Council Reference: GT1/52
Your Reference: MP06_0316 (Mod 8)

**Tweed Shire Council comments on proposed modification of the
Cobaki Residential Development Concept Plan (MP06_0316 Mod 8)
in relation to the proposed increase in building height and reduced
Town Centre**

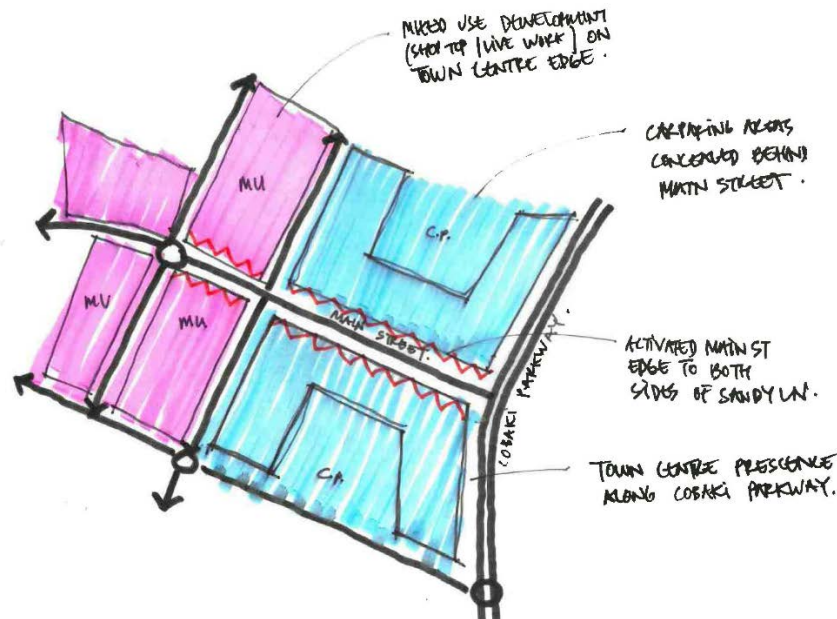
- One significant change is that rather than activating both sides of the neighbourhood connector road (Sandy Lane), the Town Centre uses would be confined to the southern side only with residential uses fronting the north side of Sandy Lane. It is noted that a reconfigured 'Main Street' would then run perpendicular to Sandy Lane and would be double sided with town centre uses.

- Whilst a scale or dimension has not been provided, the proposed 'Main Street' appears quite short and would be limited in the amount of available retail frontage along its length. Based on the Indicative Concept Plan of this precinct (Section 6.7 of Appendix 5), it is noted that large floor plate uses (which typically have long unbroken elevations) may occupy substantial frontage which would undermine the opportunity to effectively activate this space.

- The preferred configuration of the reduced Town Centre footprint would be the retention of retail and commercial activation to both sides of Sandy Lane, within a more confined envelope in response to the revised Town Centre GFA size recommendations (refer to sketch below). Whilst some nose-in parking could line both sides of the Sandy Lane, the more substantial at-grade car parking areas could be concealed to the rear of both blocks. This is a configuration not dissimilar to the Casuarina Town Centre.

b. Alternate Concept of Cobaki Town Centre Sketch

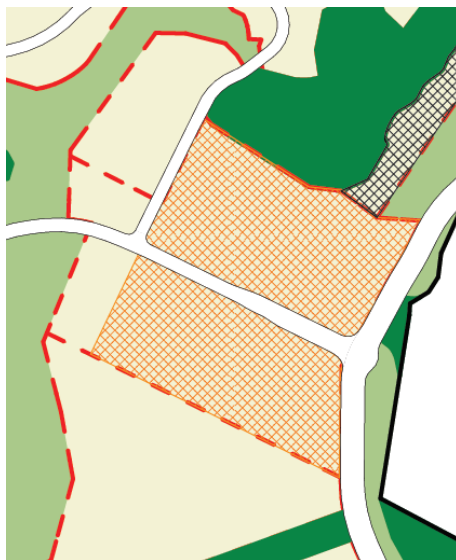
- As noted in the sketch above, an alternative to the proponent's Indicative Town Centre configuration is to activate both sides of Sandy Lane to enable a more generously sized main street and enable the town centre to have a visual presence along Cobaki Parkway. Nose-in parking along street edge with larger at grade parking concealed to the rear. Opportunity for larger anchor retail uses to be sleeved by finer grain retail with direct access to car parking areas. Directly adjoining areas to the west as mixed use enabling ancillary town centre uses such as community facilities, shop top housing, live work and future town centre expansion opportunities.

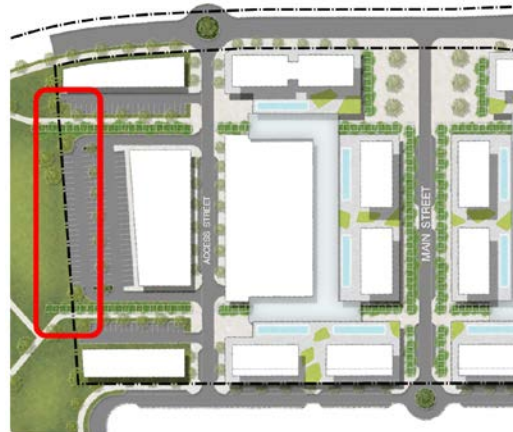
- The District Park at the eastern end of the proposed CBD does not have full road frontage. The Indicative Concept Plan for the Town Centre shows a car park and building backing onto the District Park, as noted in the image below).

- The District Park will become a key central element of the Cobaki open space network and maximum visibility and accessibility is sought. Council recommends further consideration of the Indicative Town Centre layout to maximise this important aspect of the open space network.

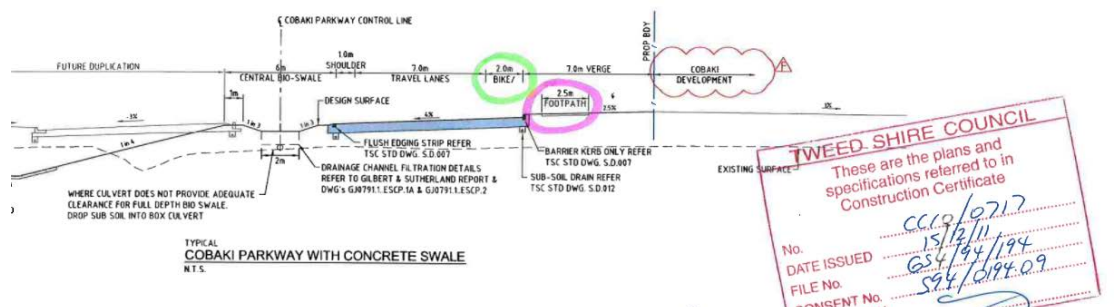
- Following on from the Built Form comments above in Item 1, Council is not in support of any direct access to residential development directly from Sandy Road.
- Figure 9 of the EA does not show the 2.0m wide on-road cycle pathway and the 2.5m wide off-road pedestrian path along Cobaki Parkway, as approved under Construction Certificate CC08/0800.01 (Cobaki Parkway North). An extract of CC08/0800.01 is shown below, highlighting the 2.0m and 2.5m pathways along Cobaki Parkway.

- It is recommended that all Mod 8 documentation be amended accordingly, including SK01.07 (Open Space Network Plan – Appendix 3) as well as Figures 12 and 15 of the Urban Design Report (Appendix 5) and Attachment 2 of the Transport & Accessibility Report (Appendix 8).
- It is noted that an additional three “shared pedestrian and cycle path” links are shown in SK01.07 (Open Space Network Plan – Appendix 3) (refer below). The new links are considered to be acceptable in providing additional open space network opportunities, noting that the final configuration and layout would be subject to detailed merit assessment of a future development application.
